26 June 2026

88 Waterloo Road Development

Response to Submissions (Architecture & Urban Design)

Waterloo Road Elevation - Podium Levels

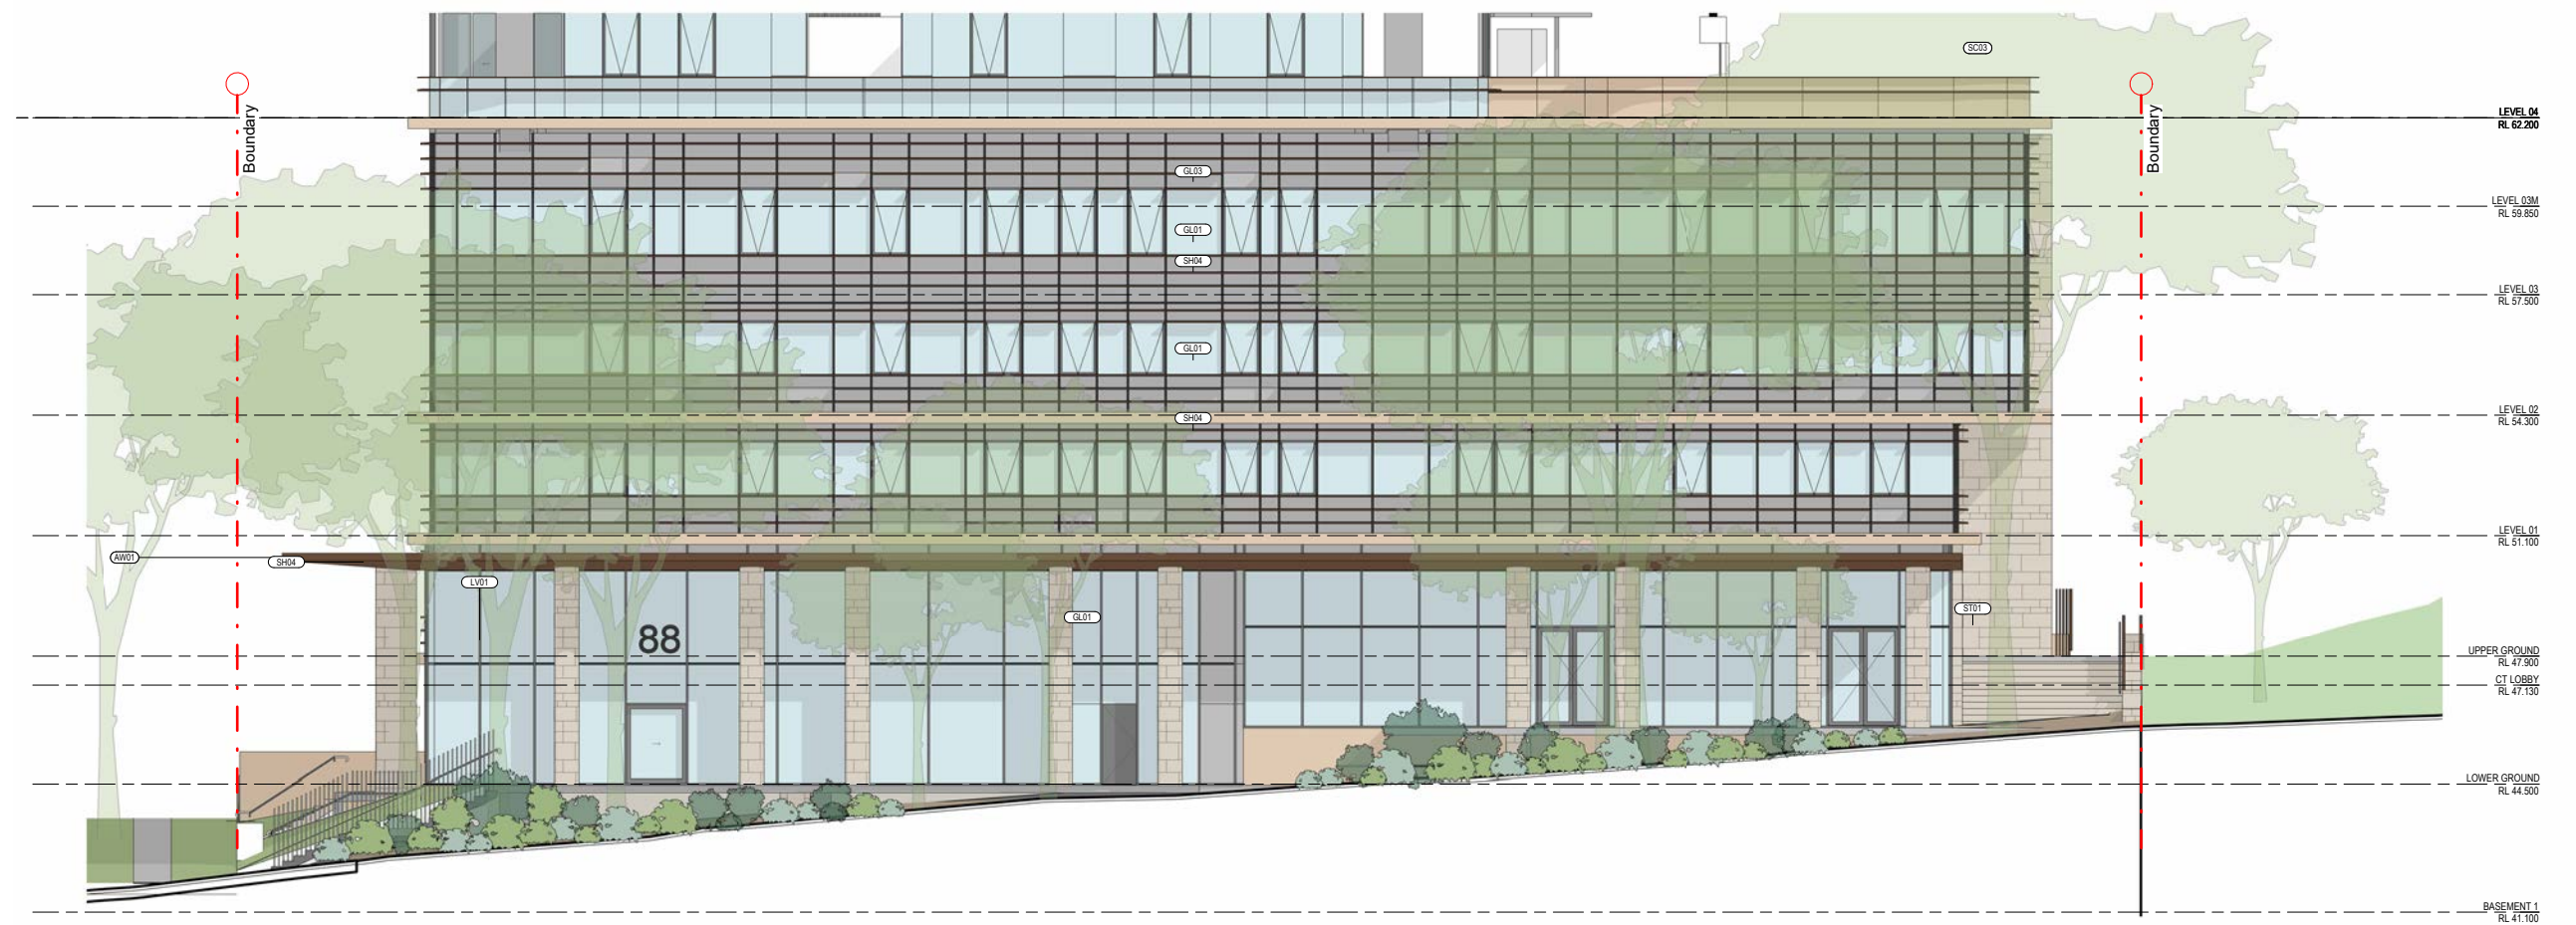
"The submitted elevation drawings do not sufficiently detail the proposal's design response to streetscape, context and public domain."

Additional 1:100 streetscape elevations have been provided with the RtS Architectural Documentation set.

Lower Ground Plan

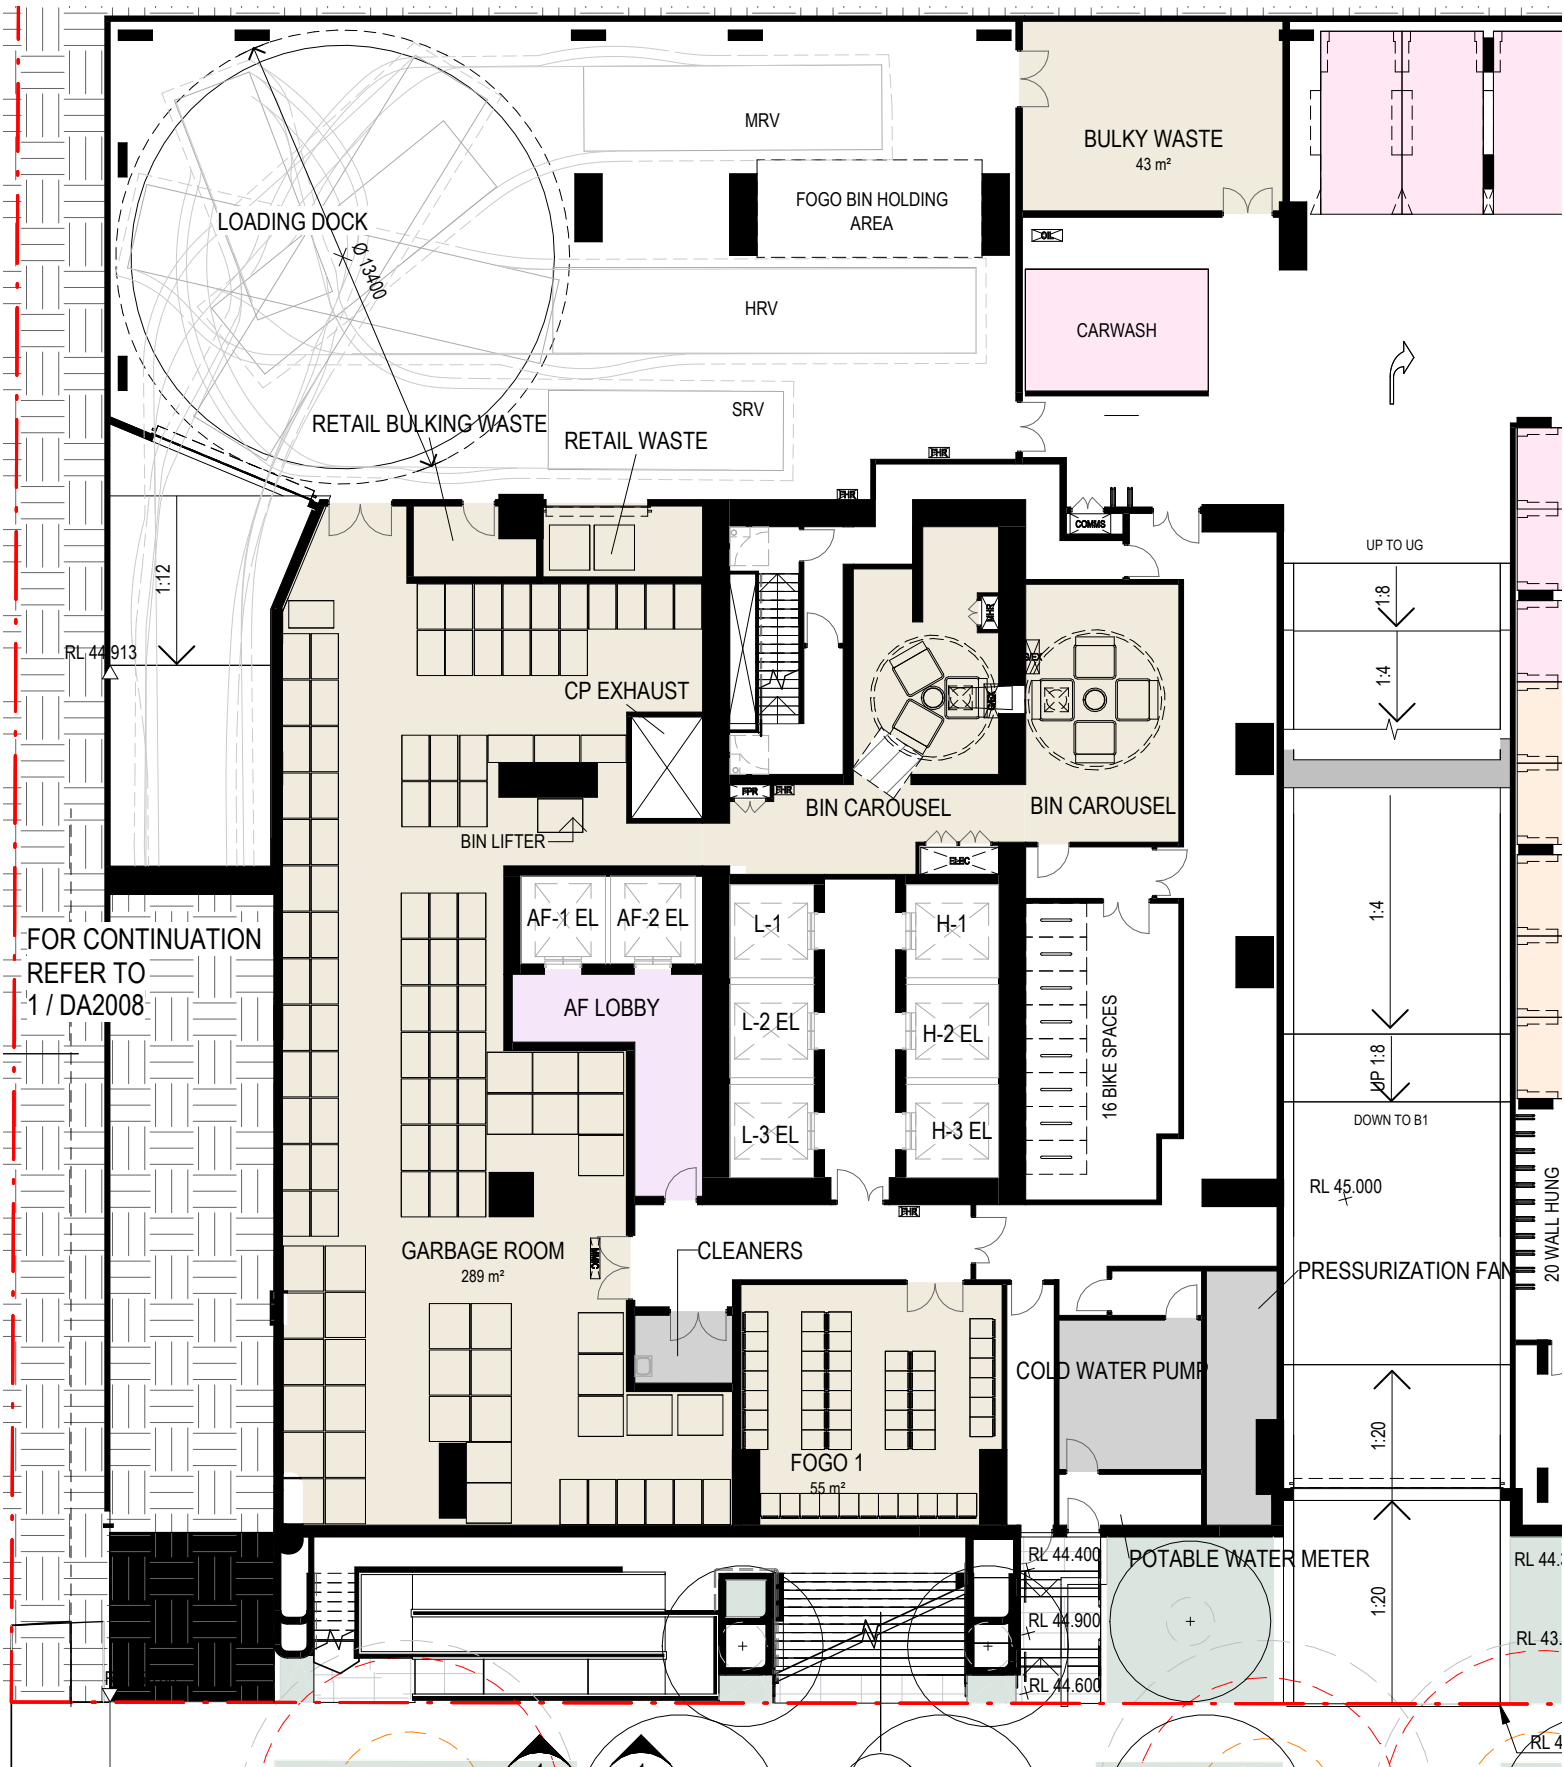
The applicant is required to redesign the waste storage and collection area and provide details to demonstrate full compliance with Council requirements. The following has not been addressed and is required:

- Provide swept paths for a heavy rigid vehicle in accordance with AS 2890.02 to ensure waste collection vehicles can safely access the site for servicing. The swept paths provided cannot be used to clearly identify the proposed transit of the 12.5 metre HRV utilised for waste collection. Swept paths must be clearly identified for each vehicle type.

- The paths detailed in the Traffic Impact Assessment do not clearly show the vehicle body therefore conflicts cannot be determined.
- The provided swept paths do not clearly demonstrate whether the proposed turntable is unobstructed from bins doors, or support structures. This space must remain clear of all obstructions to support safe and efficient servicing.

- Provide a minimum 1.5 metre door to support efficient access to bins for servicing and rotation.
- FOGO waste rooms shown demonstrate a single doorway.

- Provide a bin movement aid (e.g. tug and trailer) and suitable storage beside the waste collection area. The proposed bin movement paths are excessive for the manual movement of bins for servicing.

- Provide a minimum 5 square metres for the storage of bulky items from the commercial tenants, including furniture and pallets to reduce potential illegal dumping.

- Garbage room and FOGO rooms have compliant doorway widths.
- Truck swept paths are illustrated.
- Bin movement aid to be shown (follows Waste Management consultant advice).
- Commercial Bulky storage added to Lower Ground level next to loading dock.

Lower Ground Plan

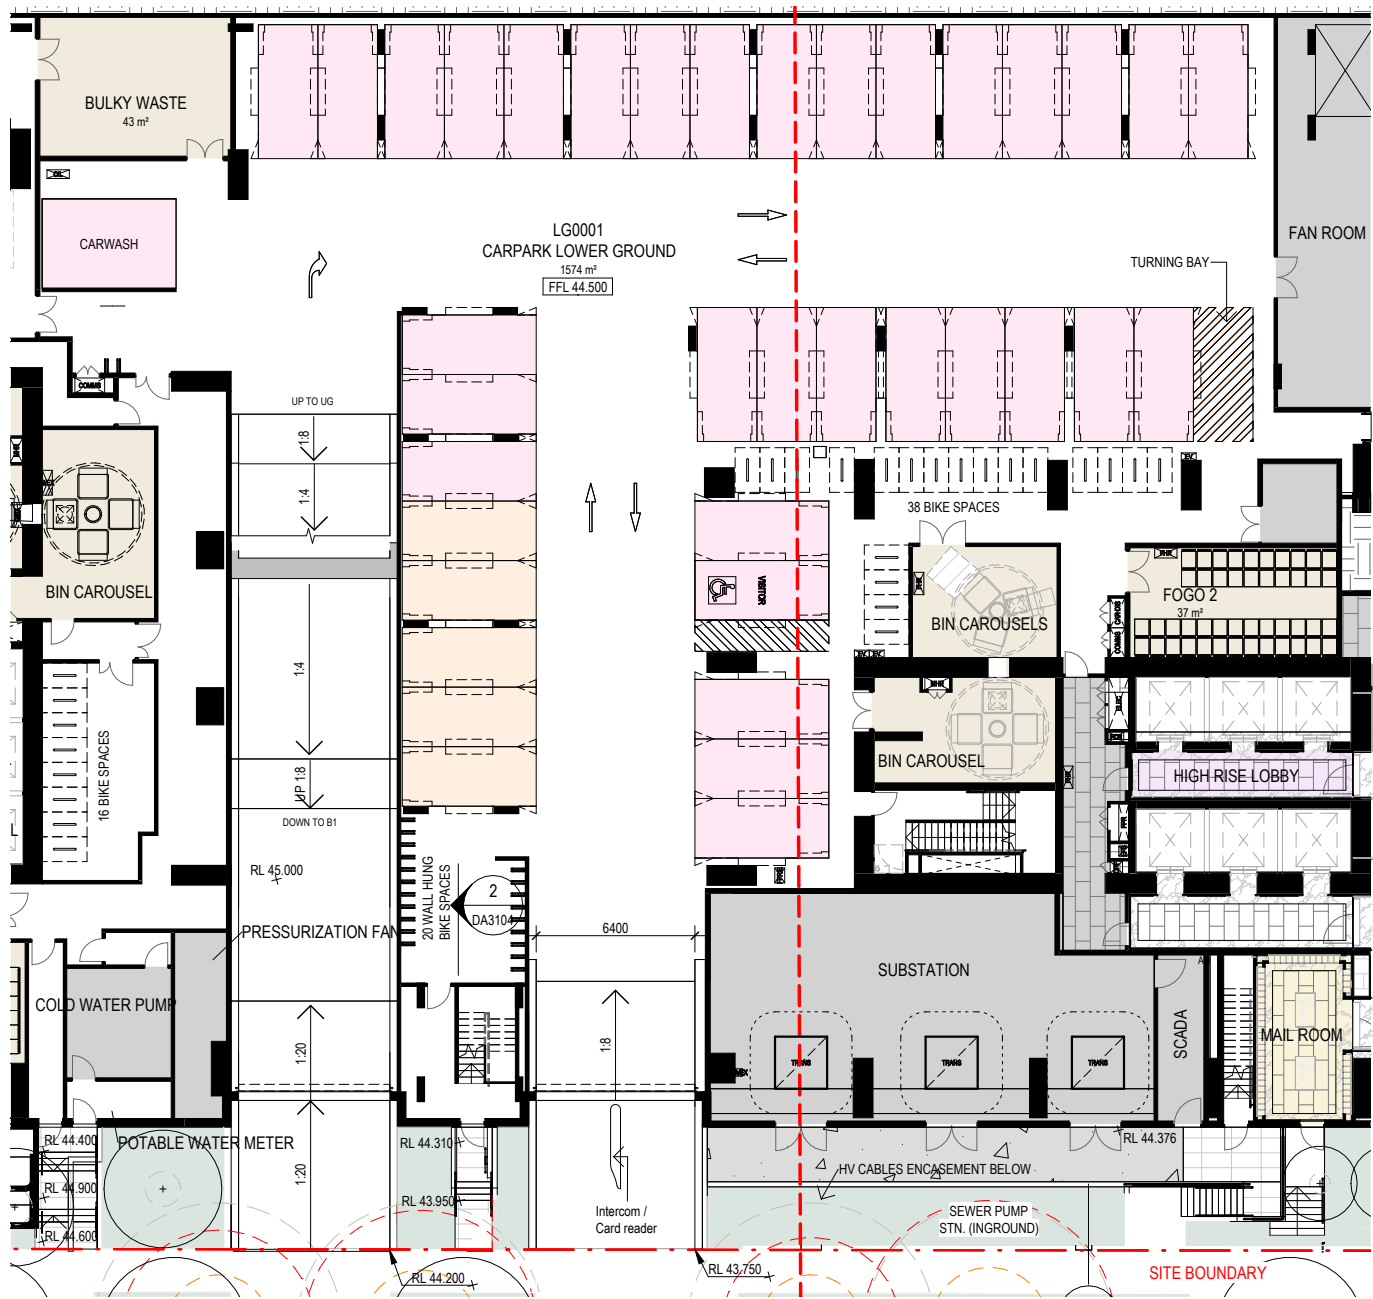
- The architectural plans should include a section taken through both internal ramps so as to confirm that the required grades and height clearances are achieved. It is understood that the driveway may require crest thresholds to be provided to prevent inundation by flood waters and therefore this may complicate a typical stacked ramp

- The visitor parking section on Lower Ground is noted to terminate in a dead end aisle that is longer than 6 parking bays. As per AS2890.1, the arrangement will warrant a turning bay to be provided at the end of the aisle.

- The Loading Dock driveway has been reduced in width to allow for sufficient clearance for the existing sewer mains running along the southern boundary. This has increased the basement setback off the boundary to 2.7m.
- A loading dock management plan will be provided to address the single lane access to and from the site.
- Additional vehicle ramp sections have been provided showing complying clearance heights and gradients and PMF levels, refer following pages.
- A turning bay has been included to the dead end aisle on the Lower Ground Plan, refer adjacent plan.
